Strathfield Local Planning Panel Meeting

Thursday, 5 March 2020

TO: Strathfield Local Planning Panel Meeting - 5 March 2020
REPORT: SLPP – Report No. 1
SUBJECT: DA2019/089/02: 7-15 WATER STREET STRATHFIELD SOUTH
LOT 1 DP603465
DA NO. DA2019/089/02

Proposal:	Section 4.55 Application to modify the conditions of consent to remove Condition 3(ii) which relates to construction of a continuous acoustic rated fence along the northern boundary of the site.
Applicant:	Pot It Pty Ltd
Owner:	Westport Pty Ltd
Date of lodgement:	2 January 2020
Notification period:	13 January 2020 – 28 January 2020
Submissions received:	Nil
Assessment officer:	LG
Estimated cost of works:	\$0
Zoning:	IN1 General Industrial - SLEP 2012
Heritage:	No
Flood affected:	Yes
Reason for referral to SLPP	Original determination undertaken by SLPP
RECOMMENDATION OF OFFICER:	REFUSAL

Figure 2: Site Plan of proposed application.

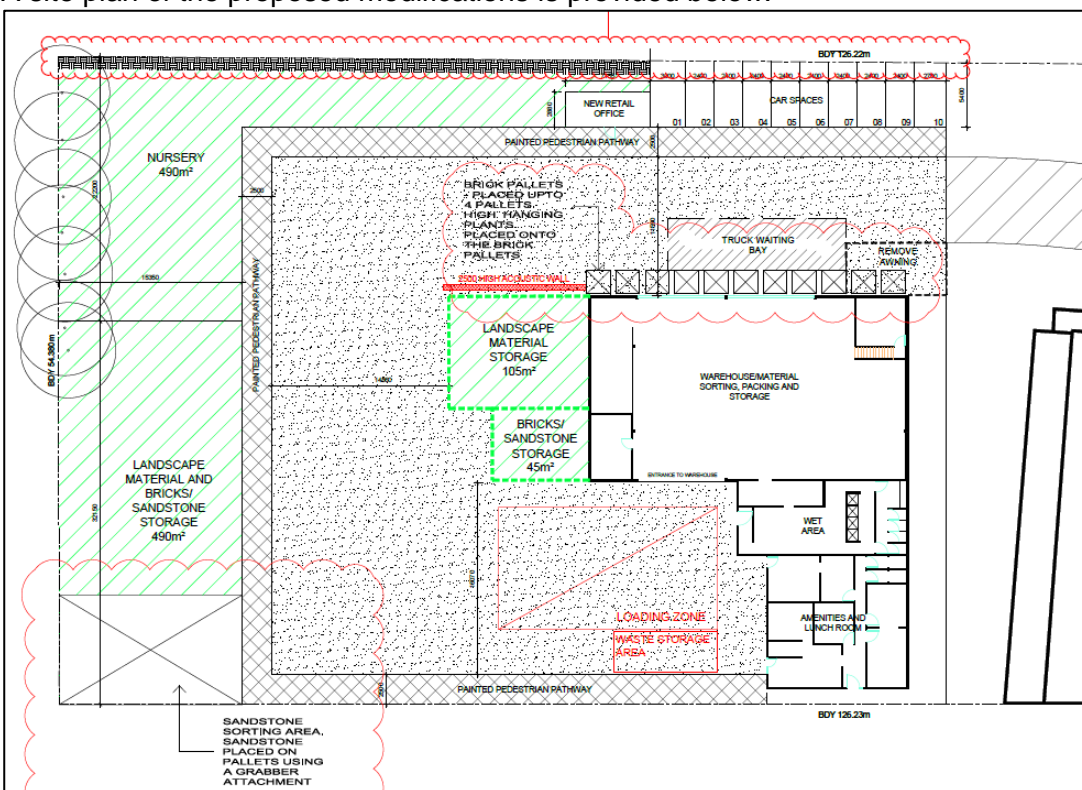
In addition, the site plan submitted with the modification shows a "truck waiting bay" on the northern side of the primary warehouse. Therefore, this waiting bay is located in between the warehouse and the northern boundary fence.

proposed landscape material storage area (Figure 2). The acoustic barrier however was not appropriately located to buffer noise arising from truck and forklift movements within the site and exiting the premises. Subsequently, Council’s Environmental Health Officer had recommended an additional acoustic barrier along the entirety of the northern side property boundary that adjoins the residential properties of William Street. The application was approved with a condition of consent to ensure two (2) separate acoustic walls be constructed on the site – one (1) adjacent the landscape material storage area and one (1) along the entire northern side boundary of the site.

The revised Site Plan submitted with the Section 4.55 Application shows a sandstone sorting area which is located within the far south-western portion of the site. This area was required to be deleted as part of the original determination. As the proposal is recommended for refusal, the plans have not been conditioned to be amended to reflect as such.

Figure 5: Building height map extract from the SLEP 2012. The subject site is outlined in red.

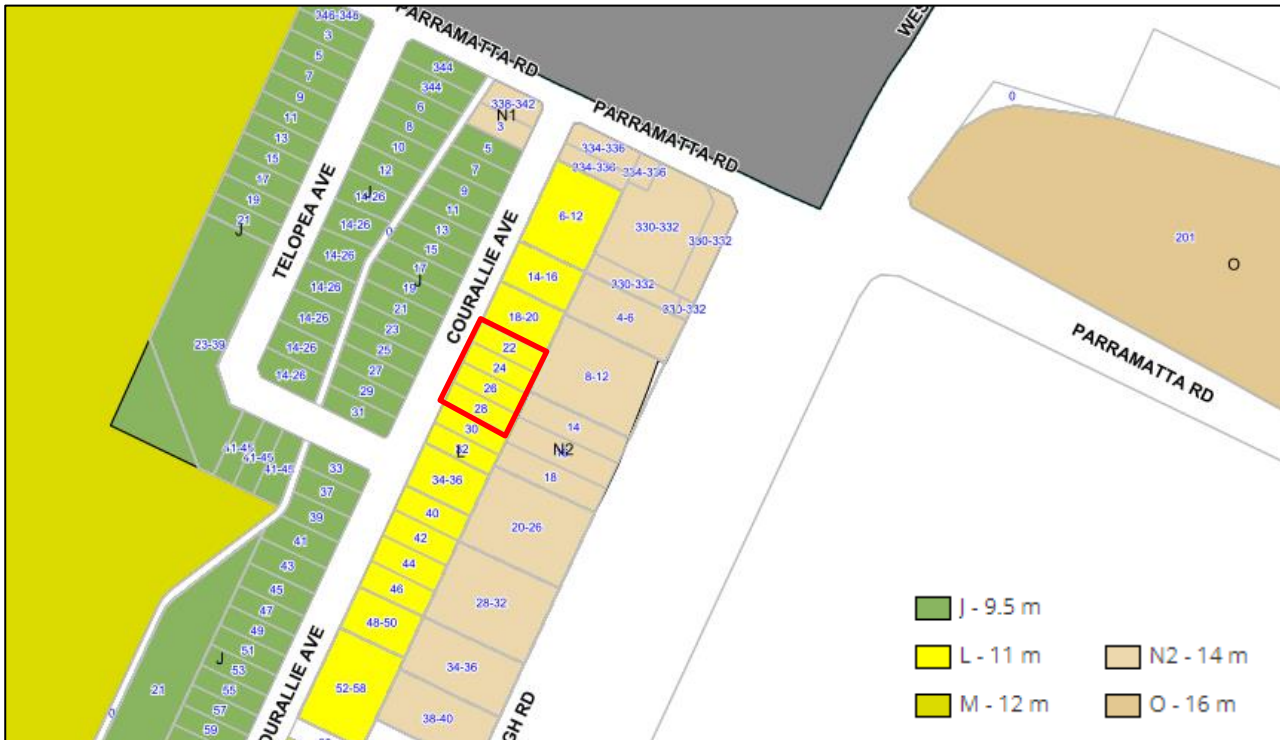
The streetscape immediately surrounding the subject site is undergoing a state of transition. As shown in Figure 5, there is a distinctive height transition from Marlborough Road (14m), the eastern side of Courallie Avenue (11m) and the western side of Courallie Avenue (9.5m). Marlborough Road comprises a mixture of residential flat buildings on consolidated and single allotments as well as undeveloped detached dwelling houses, similar to the eastern side of Courallie Avenue.

The subject site comprises four (4) residential allotments. The proposed 12.13m building height presents a 1.13m variation which is confined to the lift overrun which includes an 845mm exceedance above the building height from the internal floor to ceiling height of the top floor of the development. Figures 6 and 7 below depict the 11.75m building height approved under the latest modification application (DA2016/180/01). Figures 8 and 9 below depict the proposed modified building height which demonstrates a further yet modest exceedance beyond the maximum permitted 12m building height. The extent of the height non-compliance is attributed to the sloping nature of the site and the proposed flat roof plane.

Figure 6: Approved north-eastern view of the areas exceeding the building height standard (DA2016/180/01).

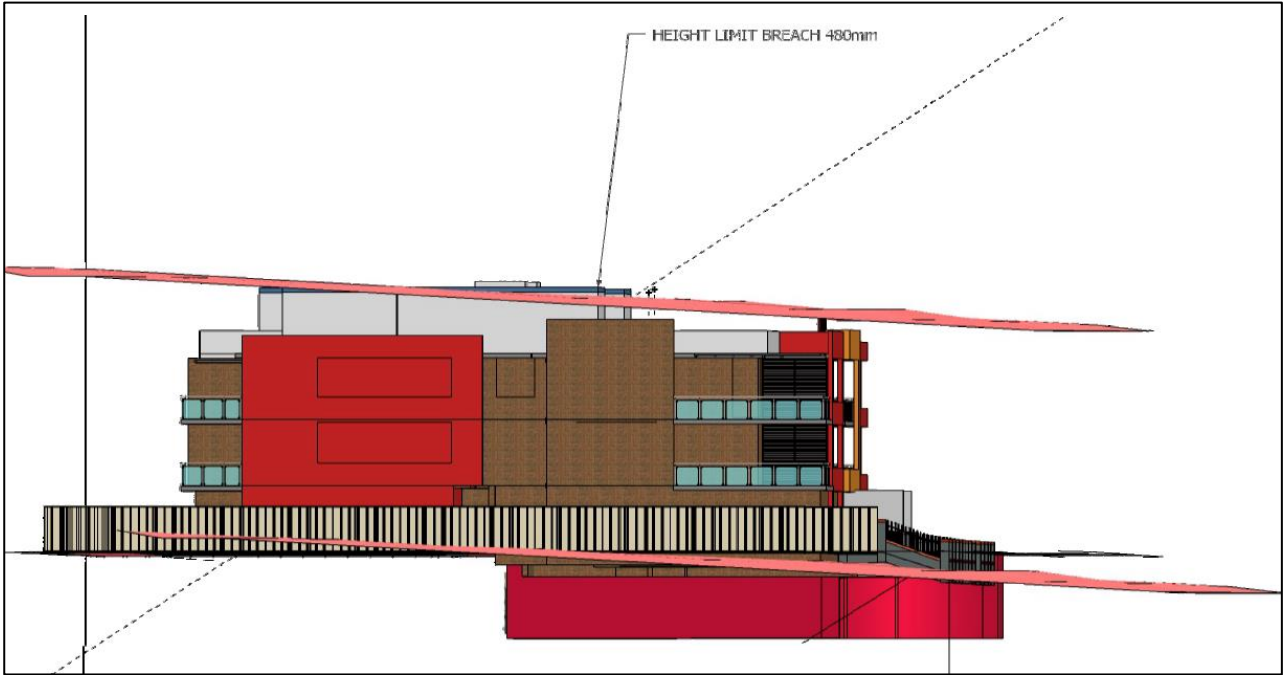
The proposed building height is consistent in establishing a height transition from Marlborough Road (14m) to the western side of Courallie and Telopea Avenue (9.5m). In regards to the eastern side of Courallie Avenue, the proposed modifications are generally compatible with the building height of residential flat buildings along the eastern side of Courallie Avenue. The extent and scale of the variation is considered to achieve an appropriate height transition from Marlborough Road to the western side of Courallie Avenue as envisaged by the SLEP 2012 (refer to Figure 10).

Figure 14: Proposed degree of overshadowing to southern adjoining property.

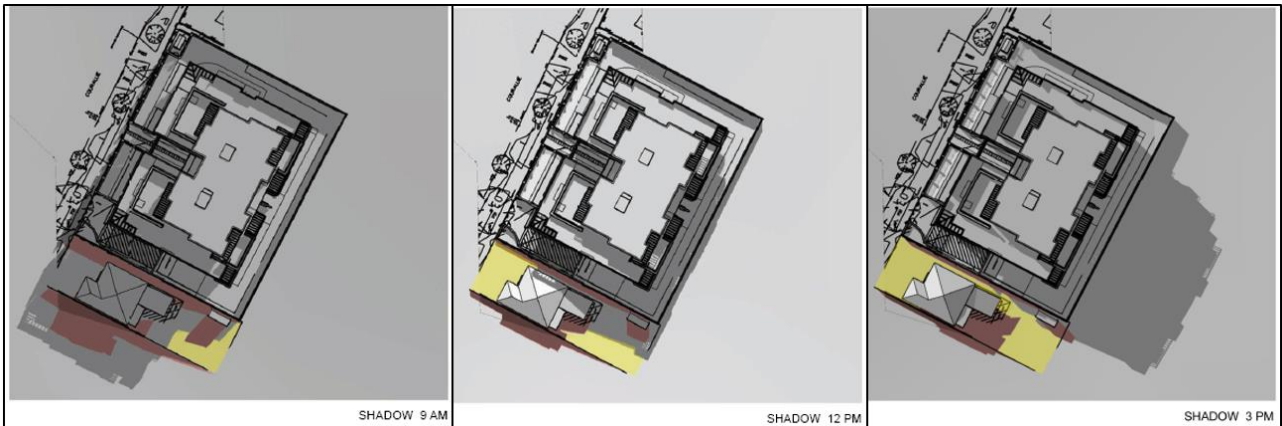
The latest approved modification application (DA2016/180/01) resulted in an increase side setback to the south from 9.4m to 12m with level 3 appearing heavily recessed from the front building line and further recessed from the front boundary of the site. The proposed modified development has sought to retain the approved building envelope with only a minor increase in building height being sought.

Figure 3: Extract of the site plan with the location of the sewerage pipe.

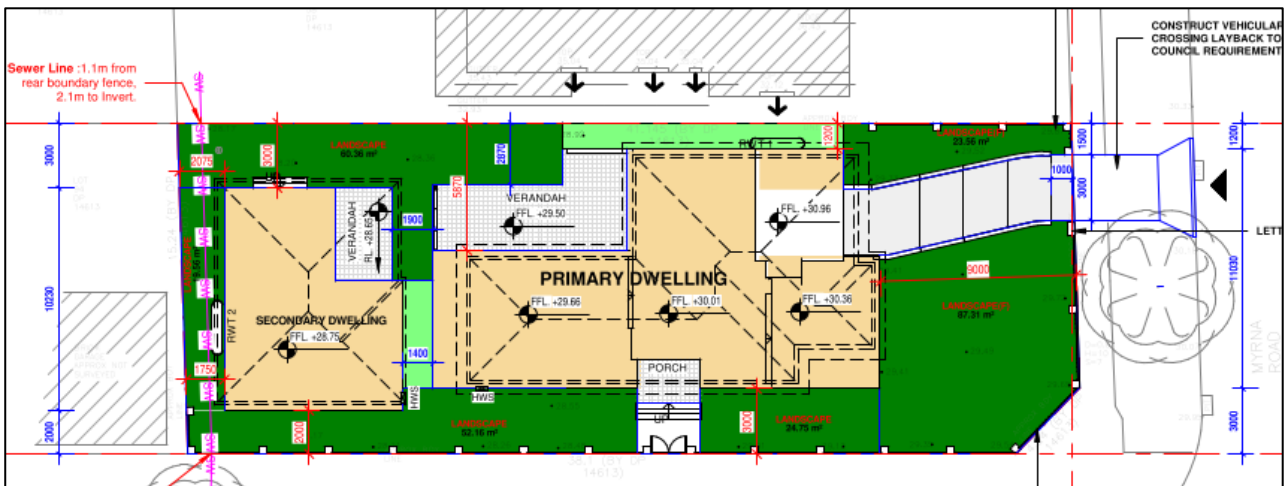
A Sydney Water sewerage pipe runs adjacent to the western side boundary (Figure 3).
